2	11/26/25	ADD SCD RM-3.1

BRIDGE NO. CUY-77-15.46
IR 77 OVER WOODLAND AVE.

ESTIMATED QUANTITIES
BRIDGE NO. CUY-77-15.46
IR 77 OVER WOODLAND AVE.

GENERAL PLAN
BRIDGE NO. CUY-77-15.62
IR 77 OVER E. 22ND ST.

GENERAL PLAN

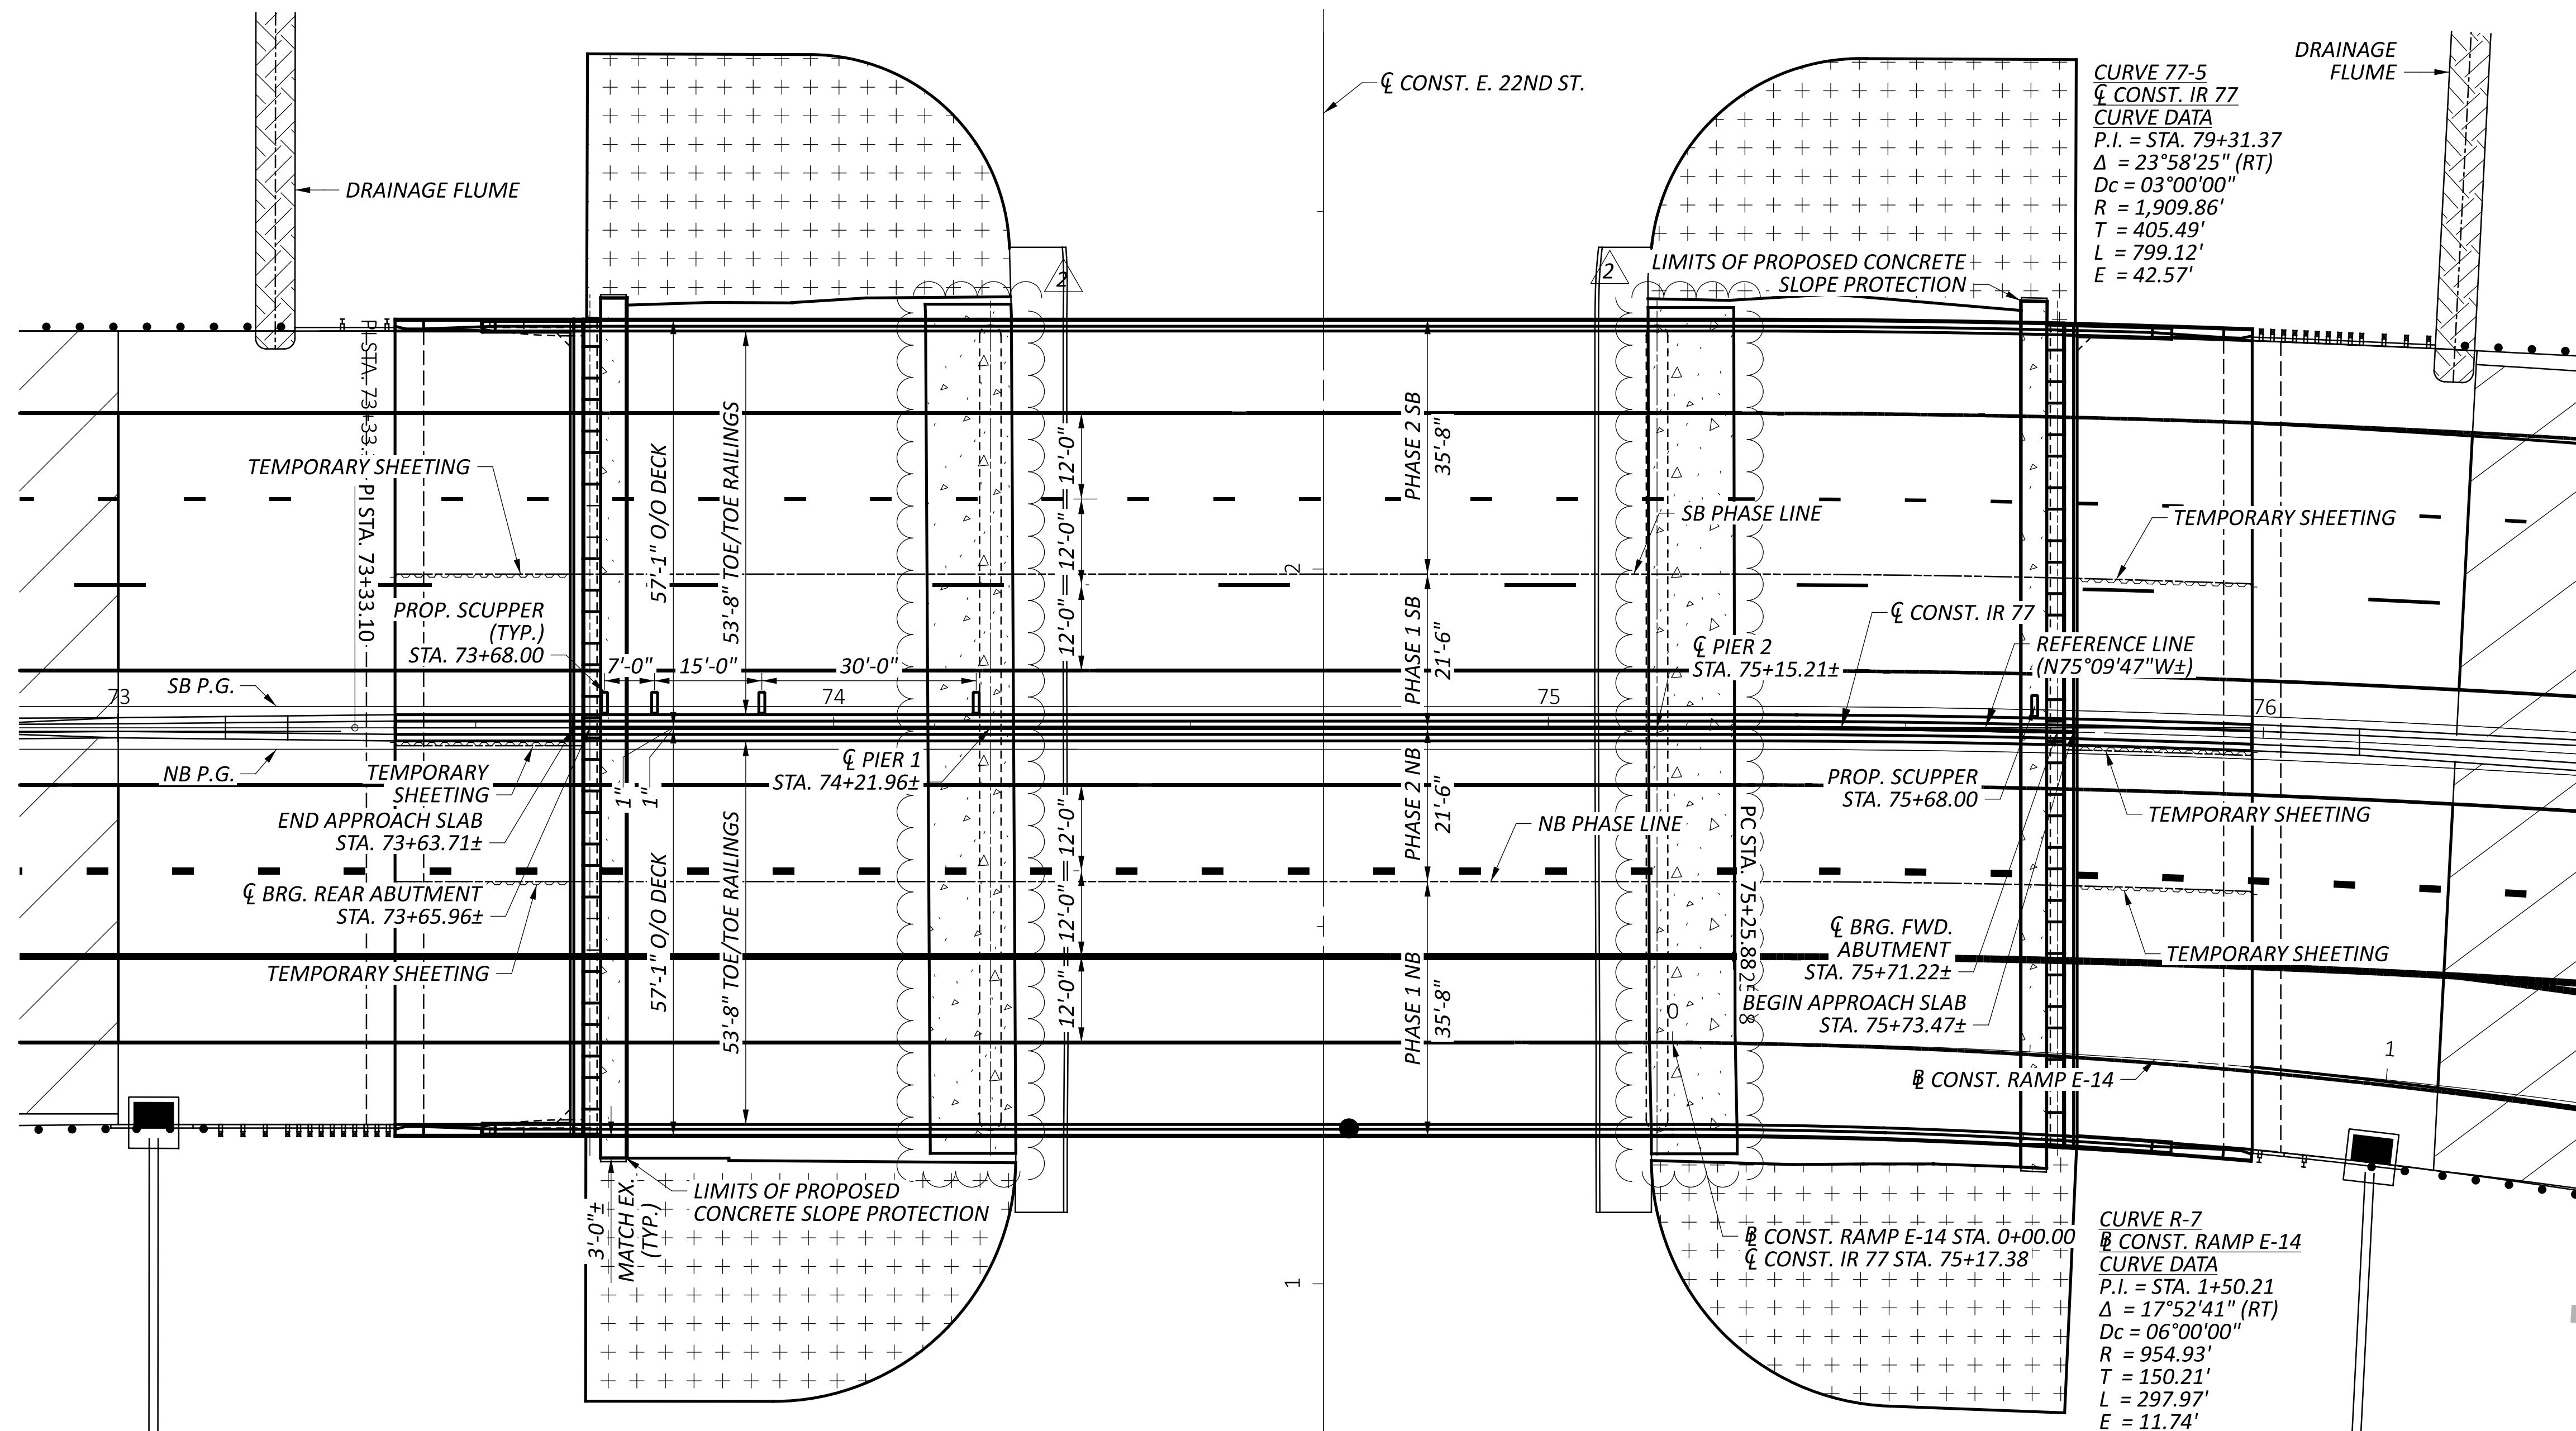
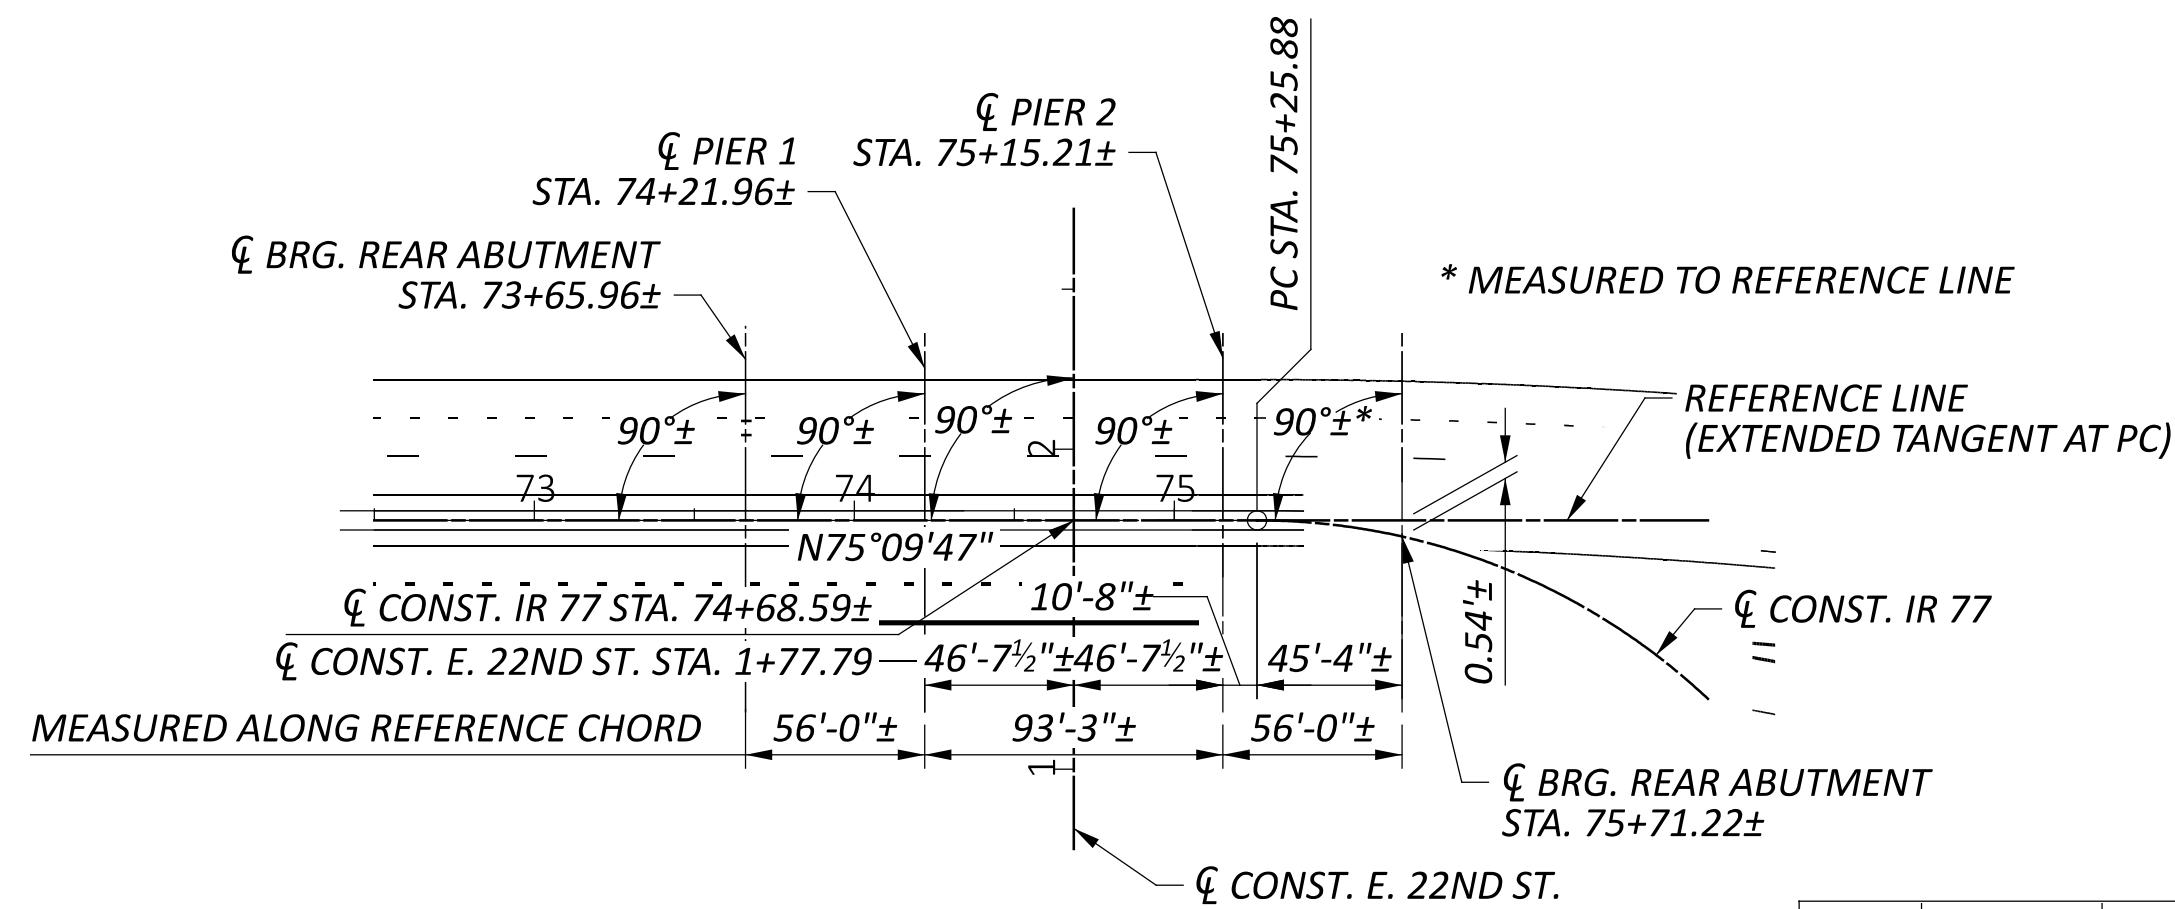
2	11/21/25	ADD CONCRETE SLOPE PROTECTION

GENERAL PLAN

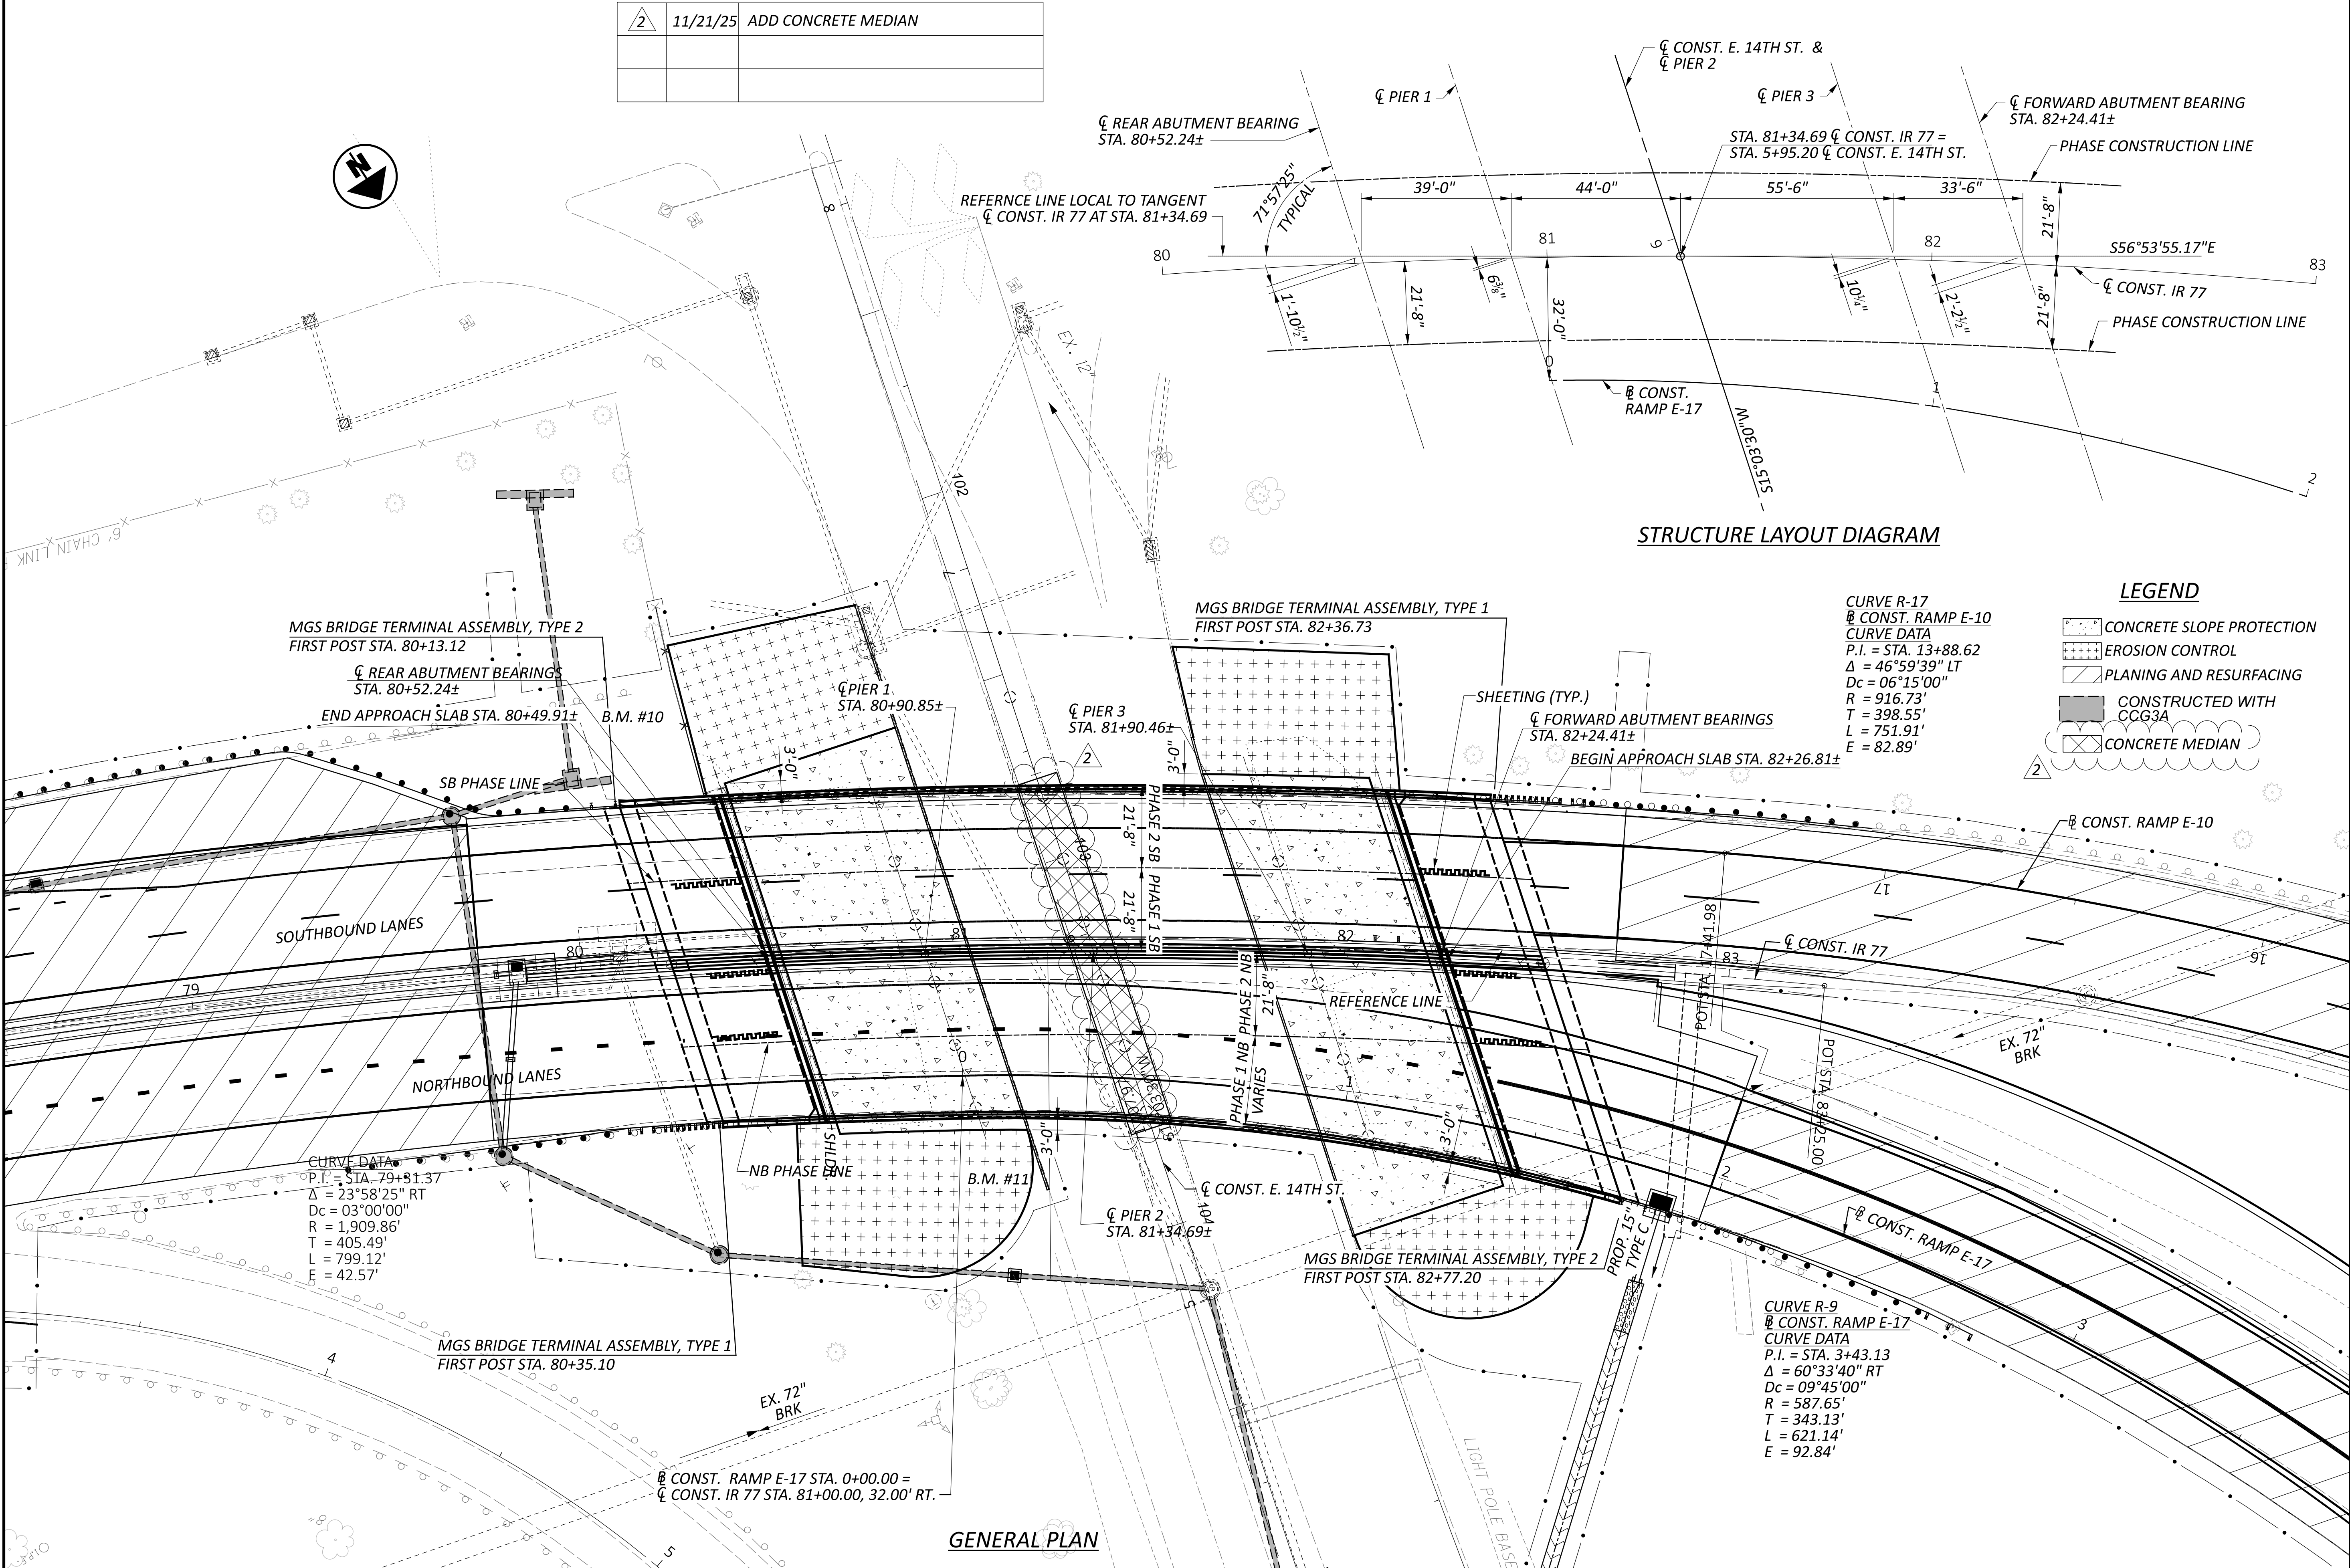
2	11/21/25	ADD CONCRETE MEDIAN

DECK PLAN

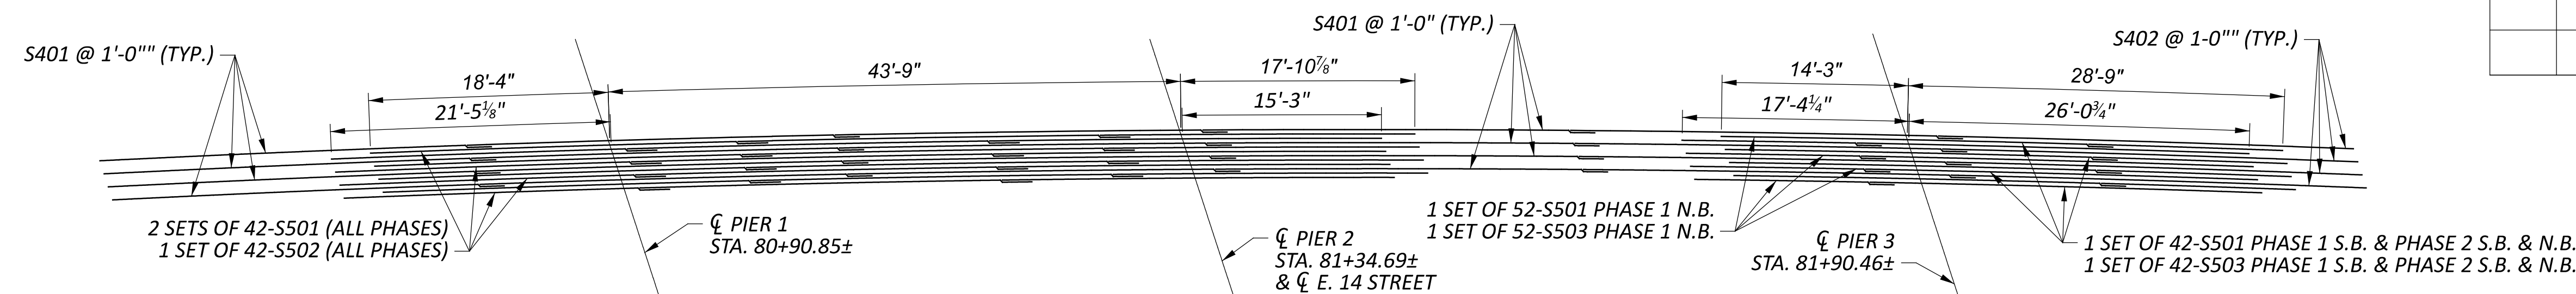
<u>2</u>	11/21/25	REVISE DIMENSION
